**BELL BEND NUCLEAR POWER PLANT
RESPONSE TO RAI NO. 115 QUESTIONS
09.02.05-28 AND 09.02.05-34 AND
SCHEDULE INFORMATION
BNP-2012-184 Docket No. 52-039**

Response to RAI No. 115,
Questions 09.02.05-28 and 09.02.05-34

Figure 9.2-12 {ESWS Blowdown Line}

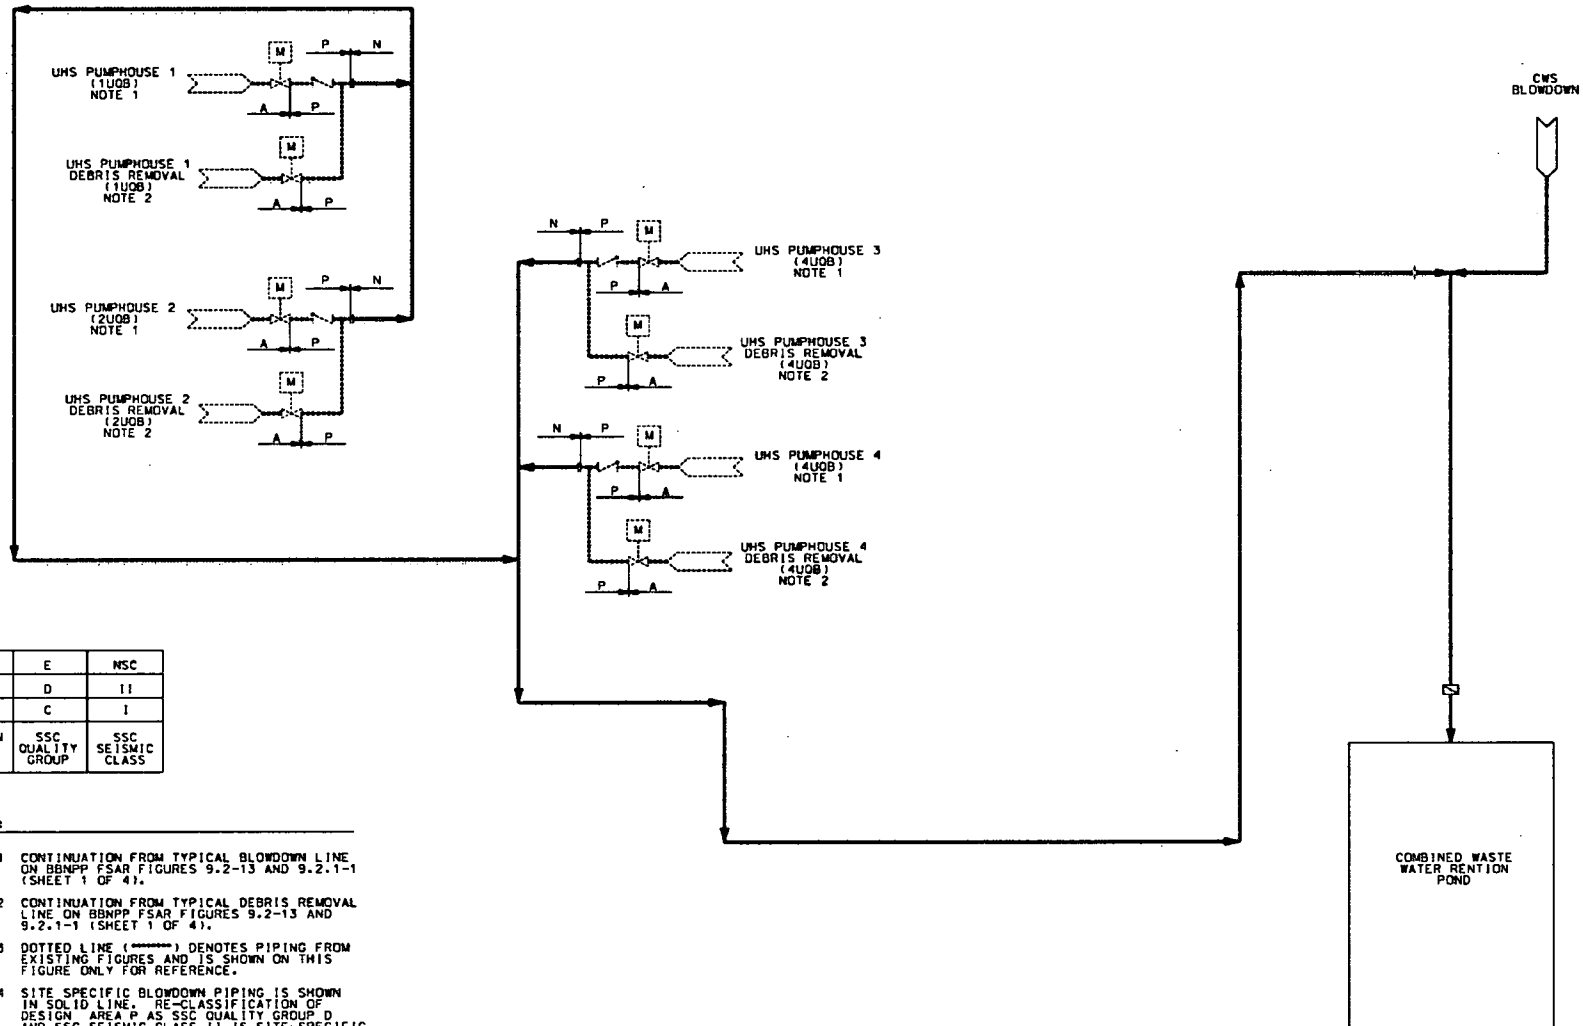
The staff's evaluation of the applicant's response and FSAR markup related to blowdown determined that clarification is needed related to the new drawings provided as FSAR markup shown on Figure 9.2-12, "EWS Blowdown Line."

- Safety-related to nonsafety-related boundaries should be added to Figure 9.2-12 clearly identifying the site specific design and certified design boundaries.
- Normal ESW strainer debris removal pipe appears to be missing from Figure 9.2- 12.

This scoping boundary and the debris removal pipe have been added to FSAR Figure 9.2-12. They already exist on Figures 9.2-13, 9.2-14, and 9.2.1-1, but have been included in Figure 9.2-12 for reference.
